Contract #: 04-0120F4Cty: SF/ALA Rte: 80 PM: 13.2/13.9File #: 69.25B**QUALITY ASSURANCE -- NON-CONFORMANCE REPORT****Location:** Changxing Island, Shanghai, P.R. China**Report No:** NCR-000473**Prime Contractor:** American Bridge/Fluor Enterprises, a JV**Date:** 08-Oct-2009**Submitting Contractor:** Zhenhua Port Machinery Company, Ltd (ZPMC), Changxing Island**NCR #:** ZPMC-0446**Type of problem:****Welding****Concrete****Other****Welding****Curing****Procedural****Bridge No:** 34-0006**Joint fit-up****Coating****Other****Component:** Floor Beam FB303-003-096**Procedural****Procedural****Description:****Reference Description:** Damage to the base metal at the top of a cope hole during weld repair.**Description of Non-Conformance:**

Job Name: SAS Superstructure

Subject: NCR No. ZPMC-0446

Component: Floor Beam FB303-003-096

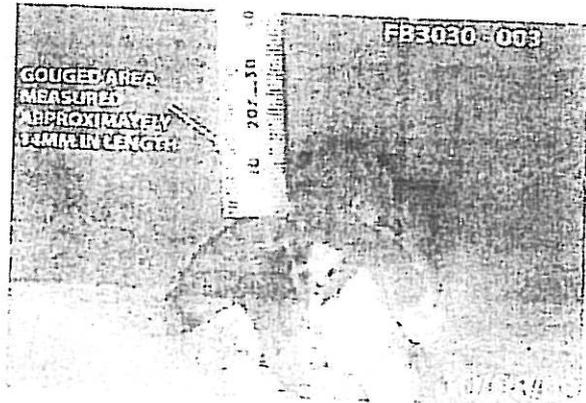
During a random visual inspection of Floor Beams located in BAY 2, the Caltrans Quality Assurance (QA) Inspector observed ZPMC performing a weld repair on Floor Beam FB303-003-096 (Lift 12E at PP 113, 114 and 115) as per weld repair report B-WR7901. During this repair process, it was observed that the welder gouged into the top of the cope hole area approximately 14mm in length and 9mm in deep. This created damage to the base metal at the top of the cope hole. The cope's radius and size is now deviated from the approved drawings.

AWS D1.5 2002 Section 3.3.2; "In all thermal cutting, the cutting flame shall be so adjusted and manipulated as to avoid cutting beyond (inside) the prescribed lines. Steel and weld metal may be thermally cut, provided a smooth and regular surface free from cracks and notches is secured, and provided that an accurate profile is secured by the use of mechanical guide."

AWS D1.5 2002 Section 3.7.4; "Prior approval of the Engineer shall be obtained for repairs to base metal, or for a revised design to compensate for deficiencies."

Repair damage and perform required NDT.

Base metal damage was repaired and NDT was performed to verify the repair is in compliance with Contract specifications.
